SITE AND DEVELOPMENT PLAN STAFF REPORT VENICE PUBLIC SAFETY FACILITY

February 5, 2019
18-13SP

PETITION NO.: 18-13SP

REQUEST: Site and Development Plan for the construction of an approximately 31,421± square foot public safety facility to house the City of Venice Police Department and function as an incident command center.

PROPOSED SITE PLAN

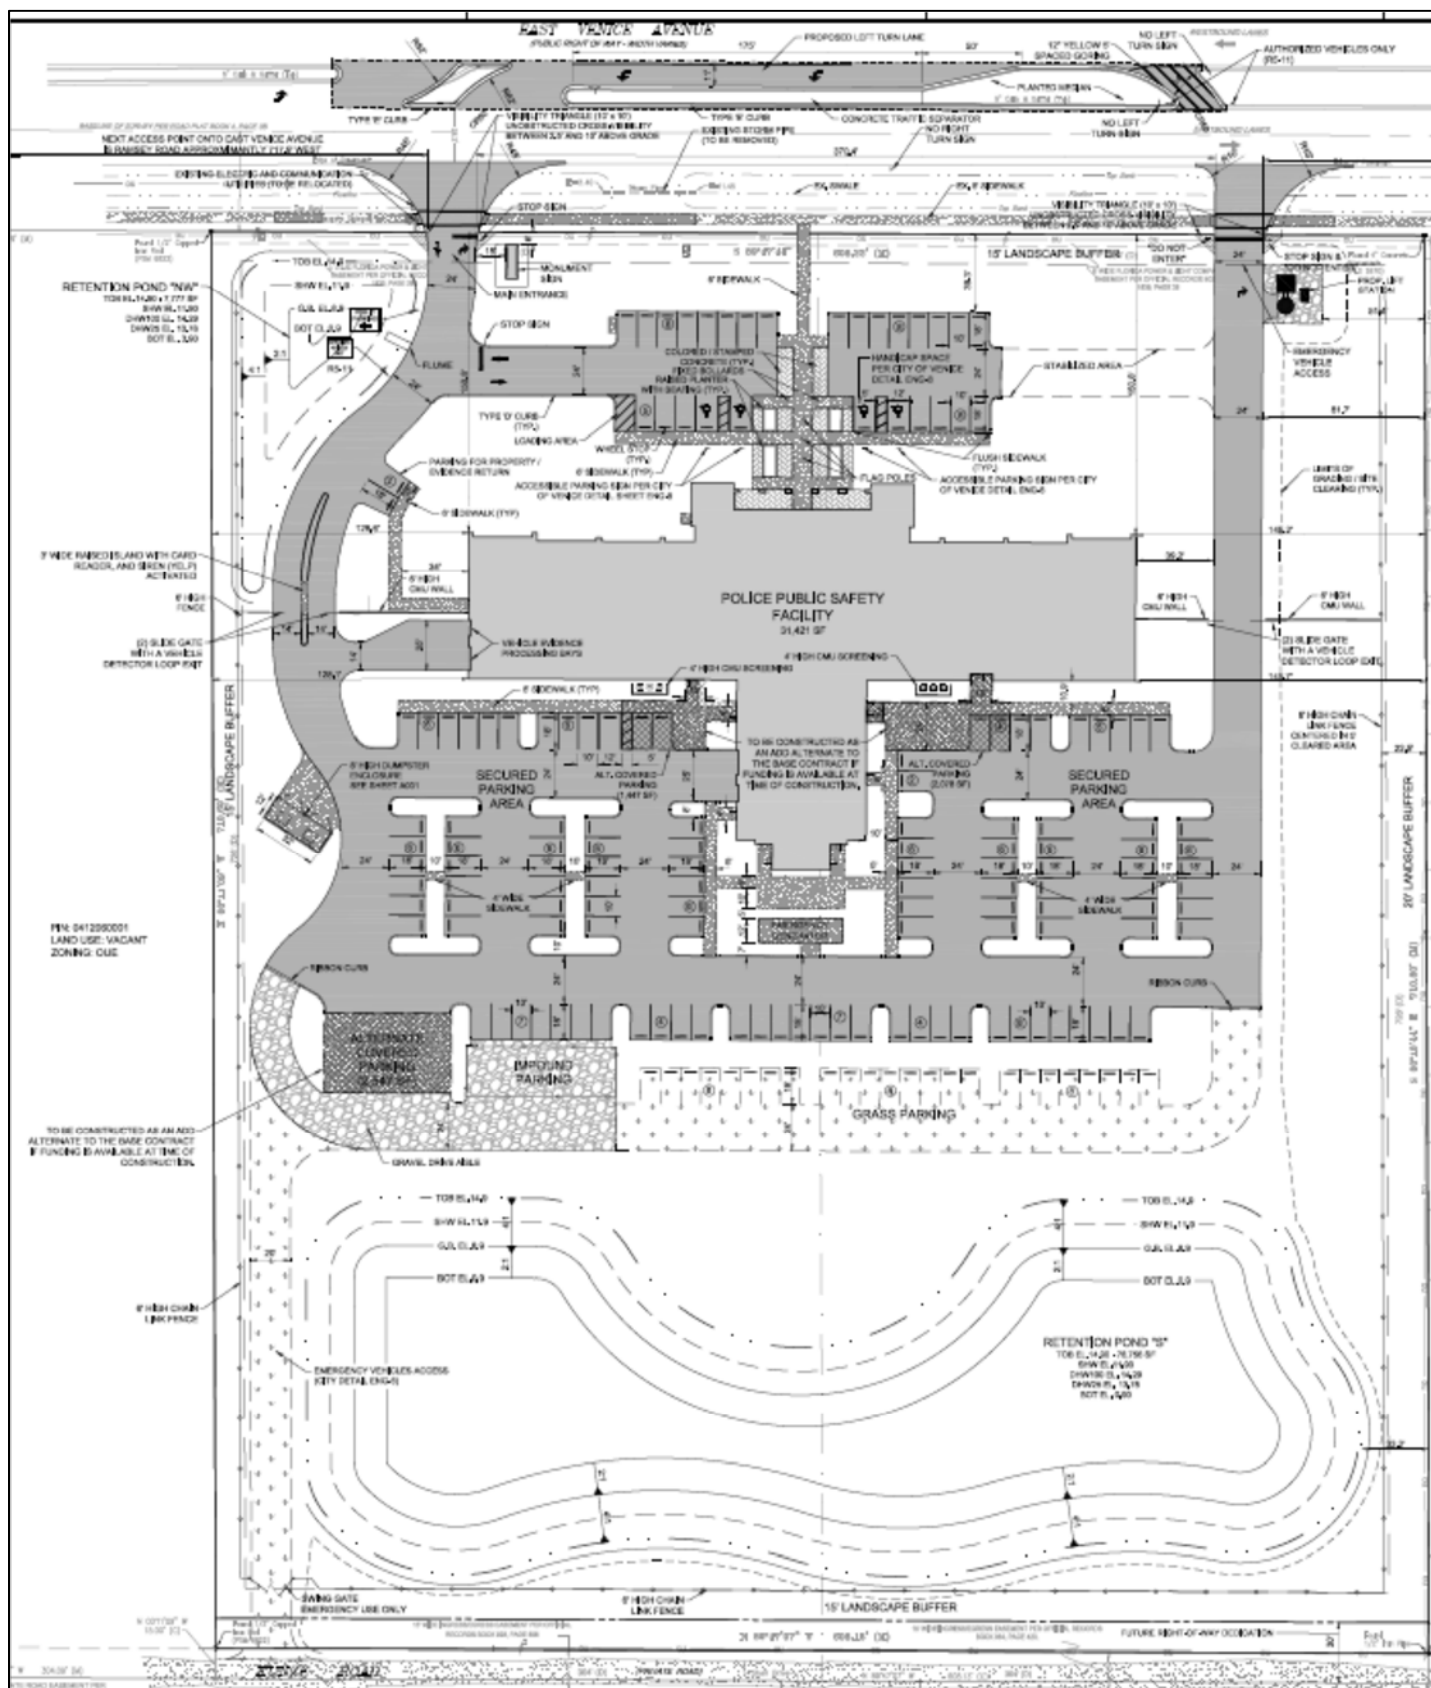
Staff Comment (I-N): The applicant has included mitigation techniques in the design of the proposed project including landscaped buffers, which include existing material (including maintaining invasive species) trees, hedges and fencing. Although no setbacks are required in the GU zoning district, large setbacks are provided. Consistent with the requirements of the VG overlay district, screening of mechanical and service areas is being provided and road access is being minimized through one public access drive onto E. Venice Avenue.

Other ingress/egress is being provided for emergency situations. The proposed 30 foot building height is consistent with the requirements of the transitional language in the Comprehensive Plan that allows for building height up to a maximum of 42 feet and the design includes elements of the required Northern Italian style of architecture.
